<b>Title - Sujet</b> Podium Slab Rehabilitation	
<b>Solicitation No. - N° de l'invitation</b> EP776-130484/A	<b>Amendment No. - N° modif.</b> 001
<b>Client Reference No. - N° de référence du client</b> R.011953.060	<b>Date</b> 2012-08-01
<b>GETS Reference No. - N° de référence de SEAG</b> PW-\$\$\$FG-345-60848	
<b>File No. - N° de dossier</b> fg345.EP776-130484	<b>CCC No./N° CCC - FMS No./N° VME</b>
<b>Solicitation Closes - L'invitation prend fin</b> <b>at - à 02:00 PM</b> <b>on - le 2012-08-08</b>	<b>Time Zone</b> <b>Fuseau horaire</b> Eastern Daylight Saving Time EDT
<b>F.O.B. - F.A.B.</b> <b>Plant-Usine:</b> <input type="checkbox"/> <b>Destination:</b> <input checked="" type="checkbox"/> <b>Other-Autre:</b> <input type="checkbox"/>	
<b>Address Enquiries to: - Adresser toutes questions à:</b> Nealon, Shawn	<b>Buyer Id - Id de l'acheteur</b> fg345
<b>Telephone No. - N° de téléphone</b> (819) 956-3391 ( )	<b>FAX No. - N° de FAX</b> (819) 956-8335

## **THE PURPOSE OF THIS AMENDMENT IS TO ISSUE ADDENDUM NO. 1**

# Addendum No. 1

project  
HOPE CHAMBERS  
BUILDING  
PODIUM SLAB REHAB  
61-63 SPARKS STREET  
OTTAWA, ONTARIO

SIDEWALK SECTION  
SECTION DE TROTTOIR

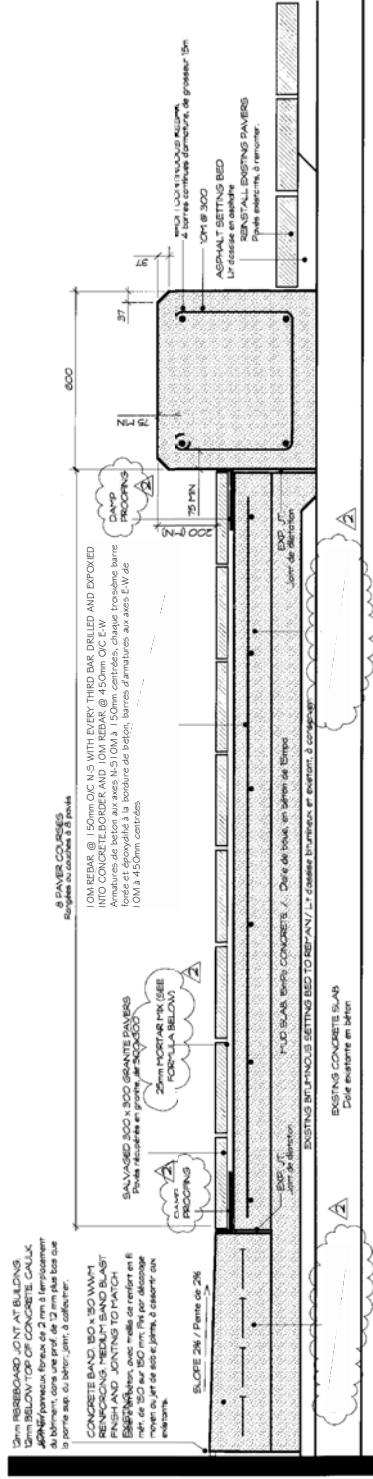
- .4      Refer to Architectural Drawing A1:  
Sidewalk slope notes have been added.
- 2      A2 Architectural
  - .1      Refer to Architectural Drawing A2 and the Supplemental Drawing A5:  
The supplemental drawing is a representation of the podium sidewalk section for reference. For the purpose of this addendum it is assumed that the lowest existing concrete slab is separate from and above the mechanical room roof slab.
